Final Report:  
Independent Design Review  
Celanese Fiber Operations  
Superfund Site  
Shelby, North Carolina  
EPA Region 4

EPA-542-R-11-001  
February 2011  
[www.epa.gov](http://www.epa.gov)

Figure 2. Flow Chart Illustrating Potential Process for Arriving at a Remedy for Diethylene Oxide

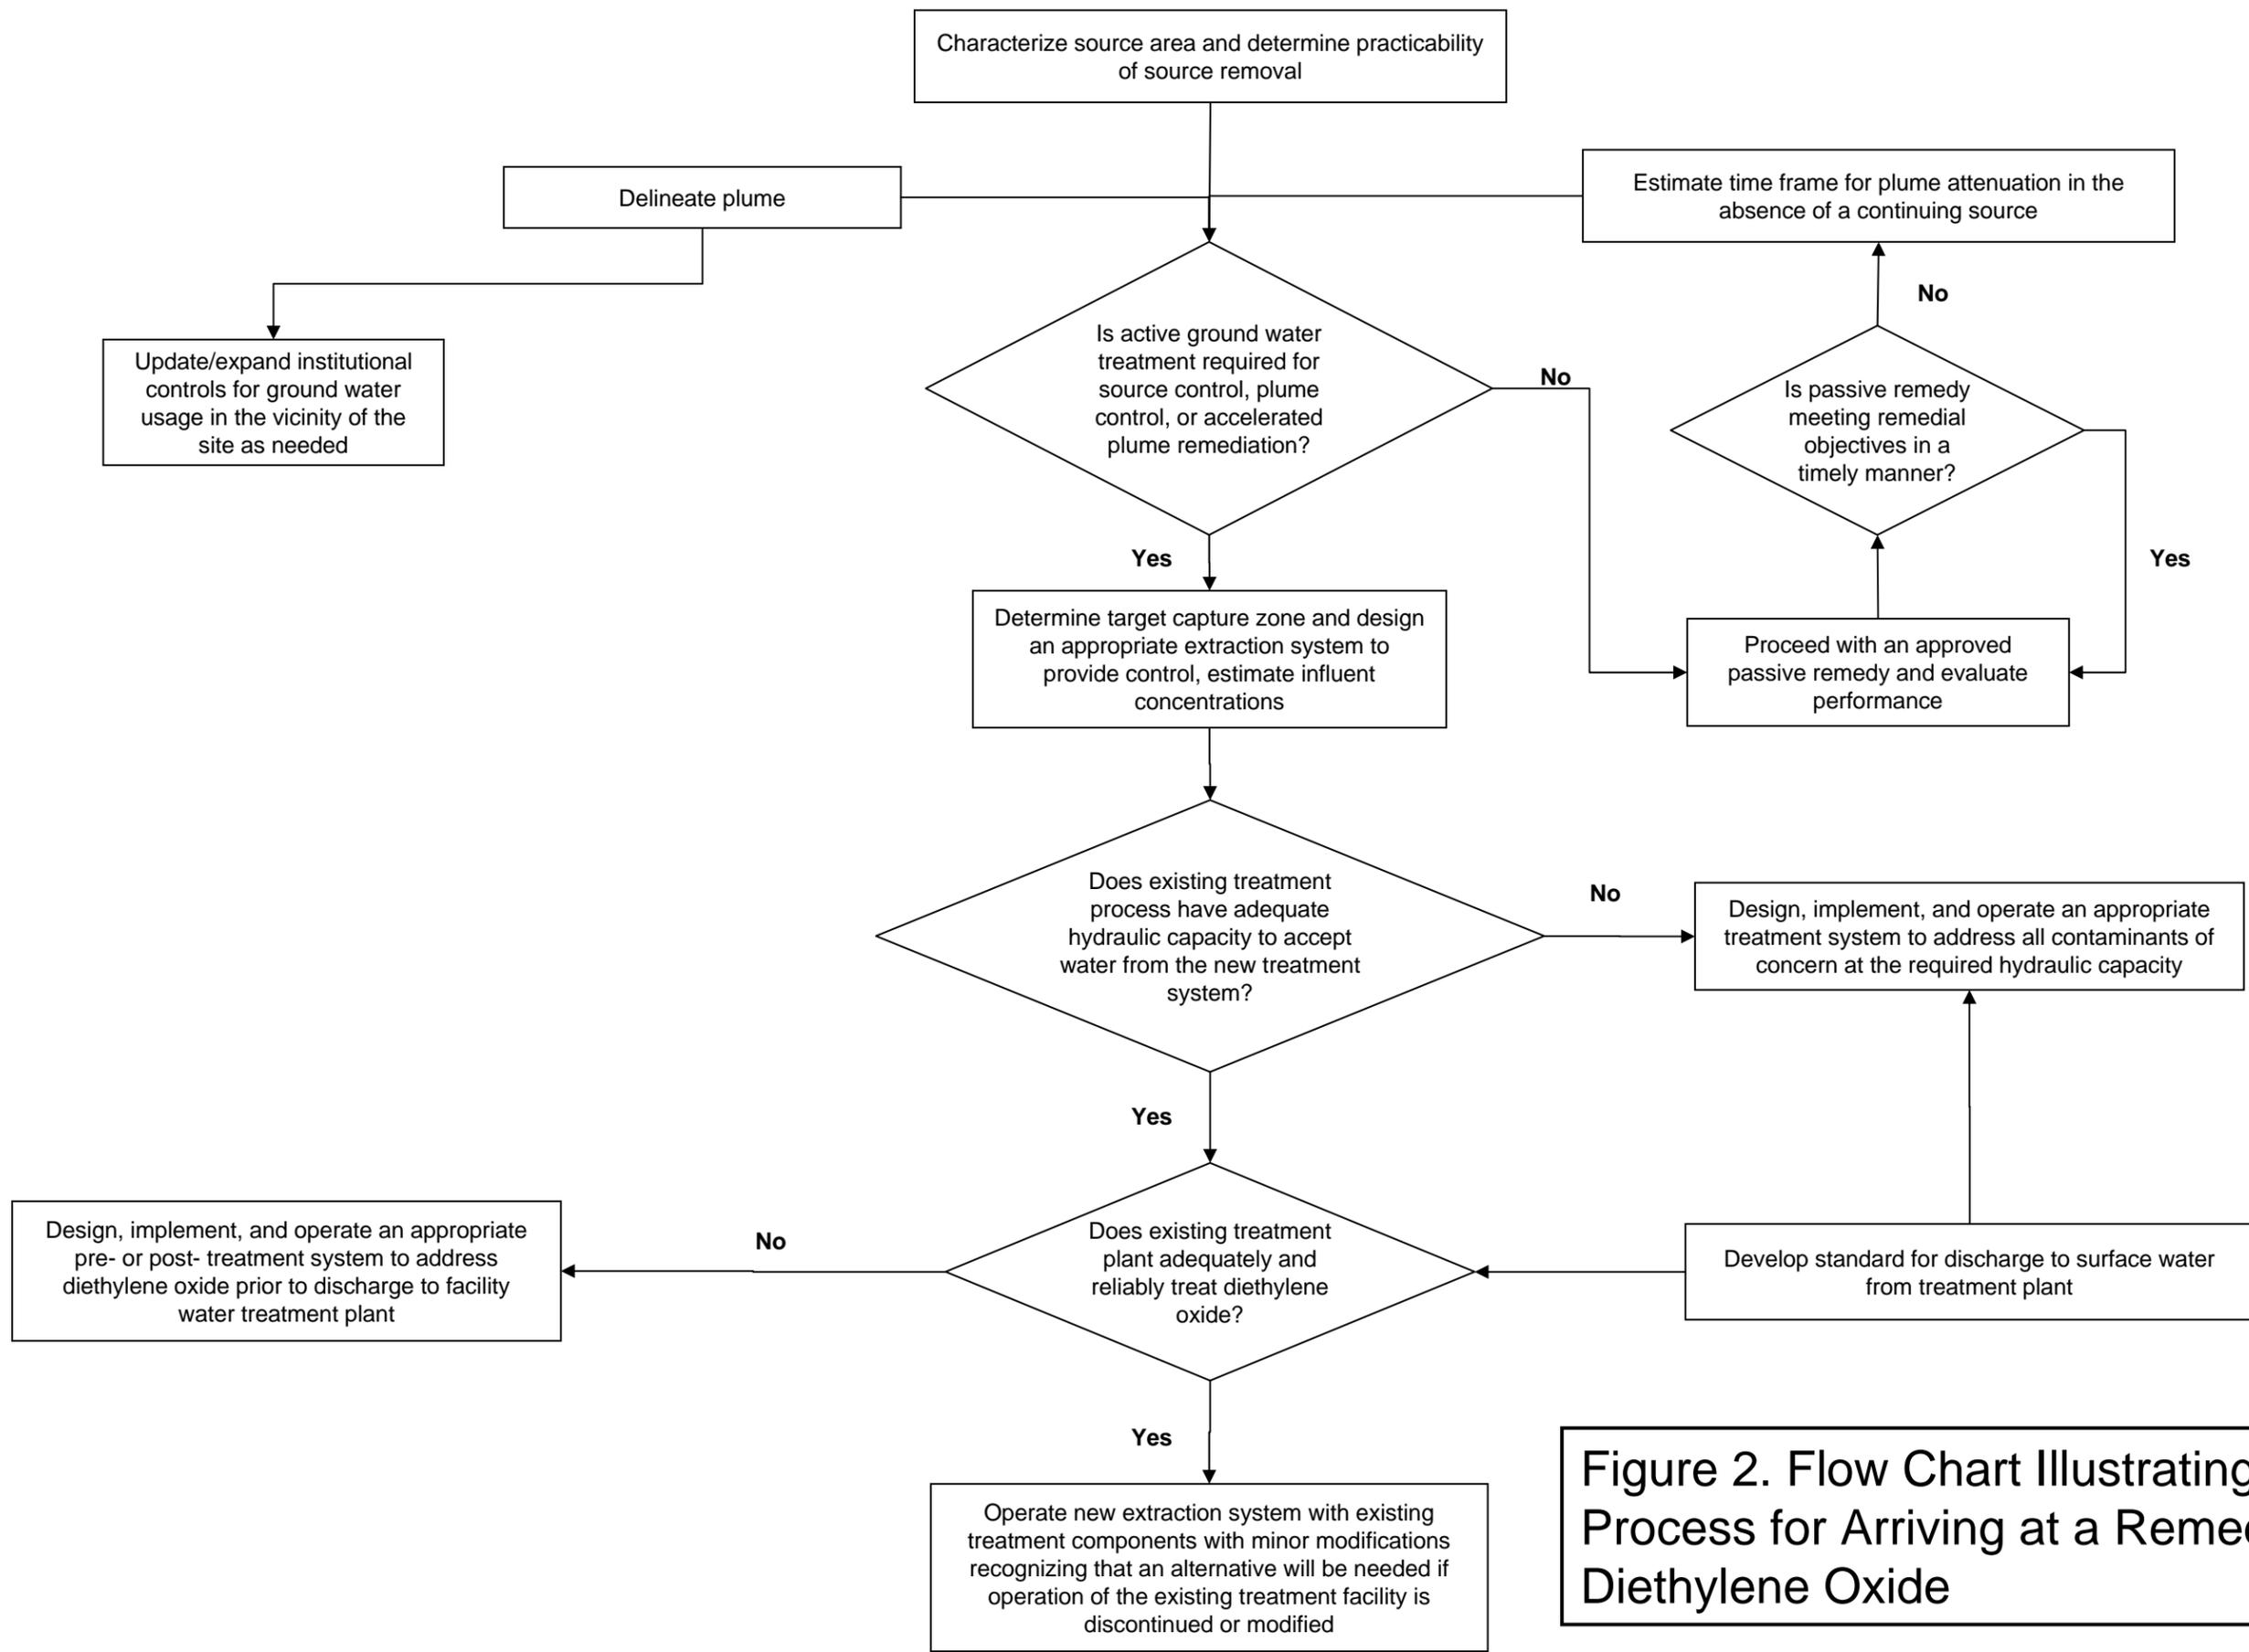
Figure 2 provides a flow chart to illustrate the potential process for arriving at a remedy for diethylene oxide. Consistent with current findings in literature, this flow chart assumes that in-situ remediation will not be appropriate for providing reliable plume control. Source removal, source control, and active plume remediation are considered as is the potential need to expand institutional controls for ground water usage in the vicinity of the site is also indicated.
